Reference: Addendum to BCP Work Plan  
Triple Cities Metal Finishing  
Hillcrest, NY  
BCP ID C704045

**ADDENDUM TO SITE INVESTIGATION WORK PLAN  
BINGHAMTON REALTY  
FORMER TRIPLE CITIES METAL FINISHING FACILITY  
4 NOWLAN ROAD  
HILLCREST, NEW YORK**

Reference: Addendum to BCP Work Plan  
TCMF Hillcrest Facility  
BCP ID C704045

<b>GeoLogic</b>		
GeoLogic NY, Inc.		
SAMPLE LOCATION PLAN		
TRIPLE CITIES METAL FINISHING CORP.		
HILLCREST, NEW YORK		
DR. BY:	SMC/SDW	SCALE: 1" = 60'
PROJ. NO:		99011A
REV'D BY:	MRL	DATE: OCT. 2006
DRWG. NO.:		1

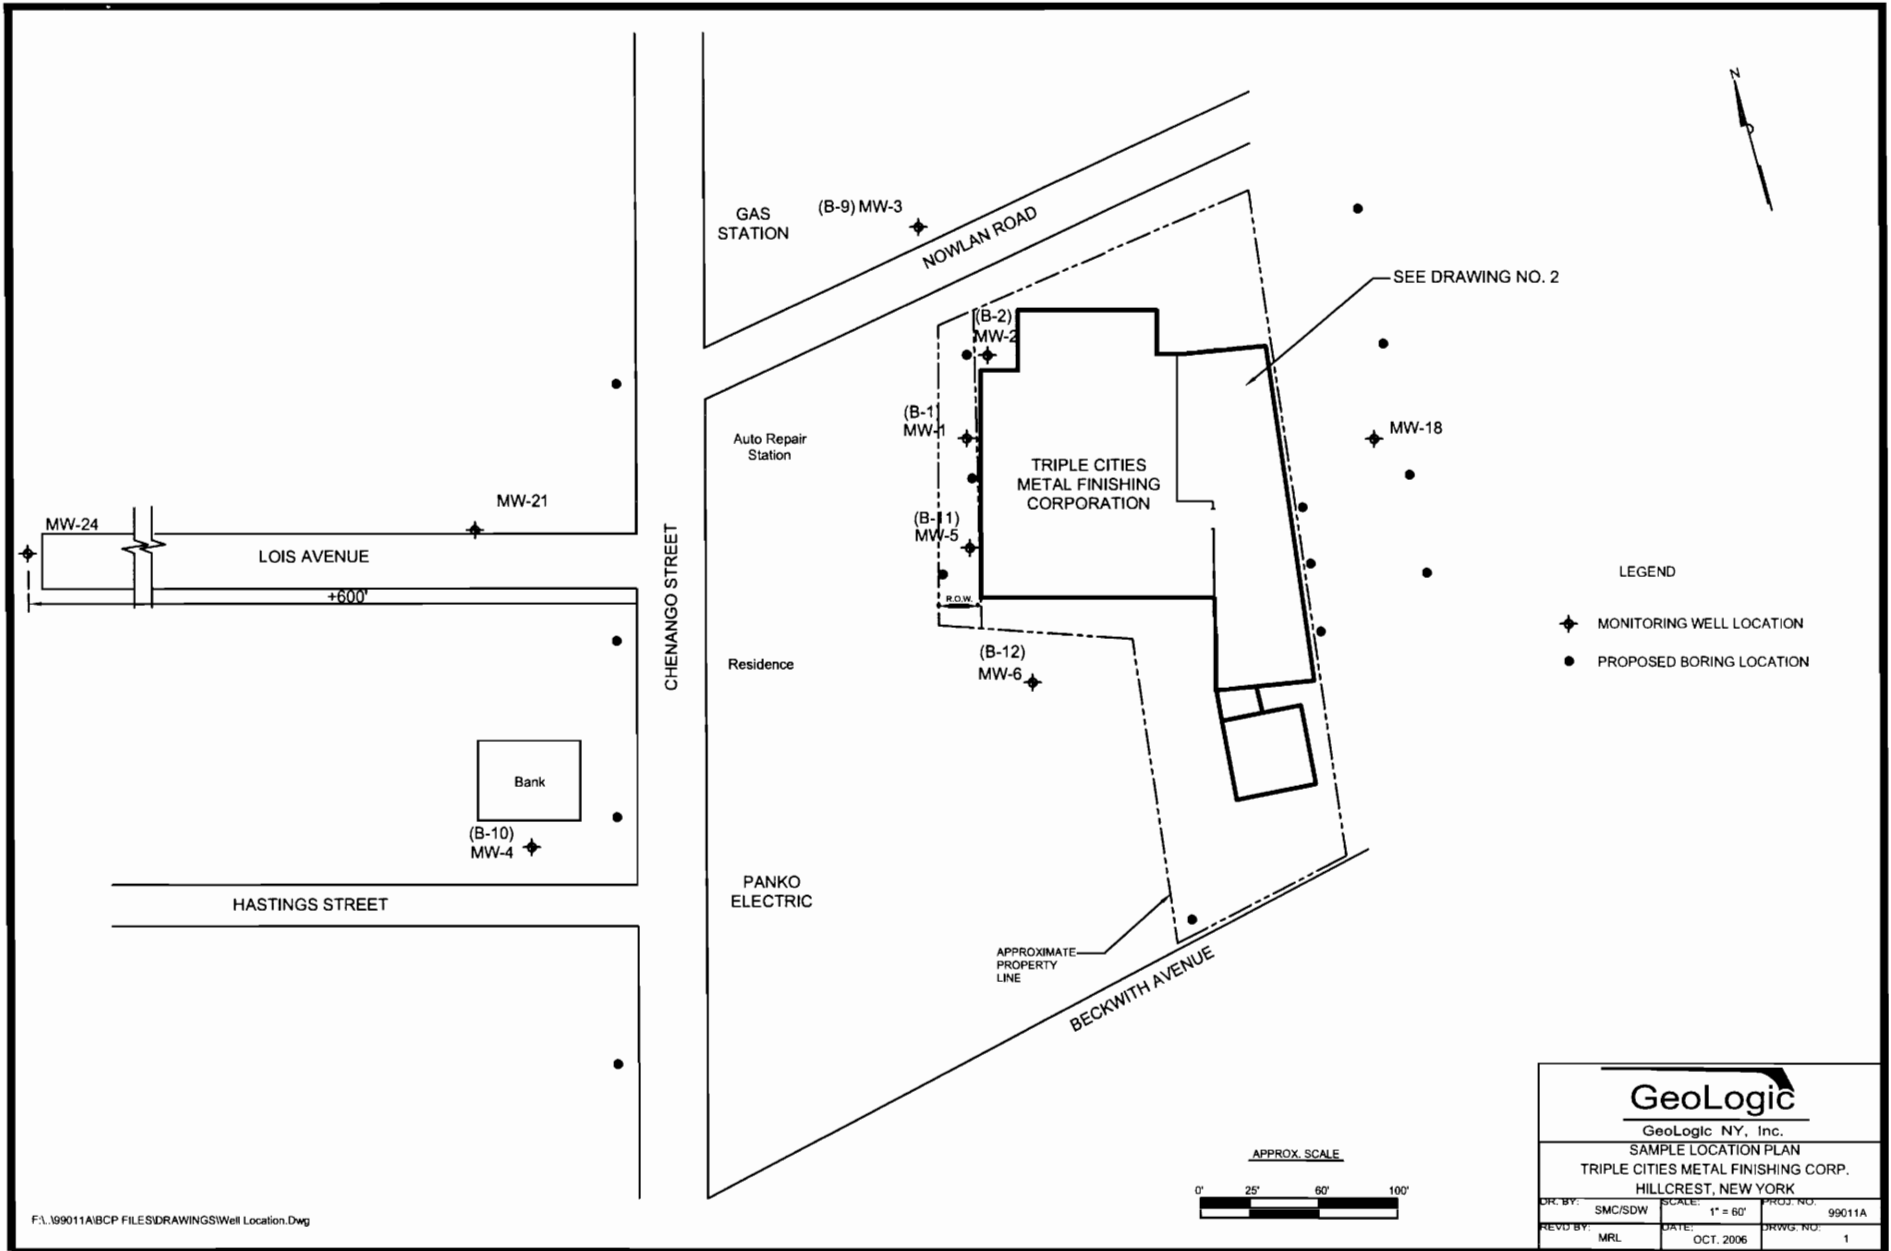
Advance borings at least 8 feet into the silt unit and collect soil samples for analyses. The silt unit is approximately 30 feet below ground surface at the TCMF property. The borings will be advanced on the east side and west side of TCMF building as depicted on Drawing No. 1. The borings on the east side of the building will be advanced adjacent to the former primary discharge structure for Outfall 001. The locations of the borings on the west side of the building (hydraulically downgradient) will be advanced at the location previously evaluated by URS for NYSDEC new MW-5 and adjacent to the two discharge structures for Outfall 002. One boring will be advanced at the southwest corner of the TCMF property along Beckwith Avenue. Four boring further east of the TCMF building and four borings on the west side of Chenango Street will also be advanced to evaluate subsurface conditions upgradient and downgradient of the TCMF property;
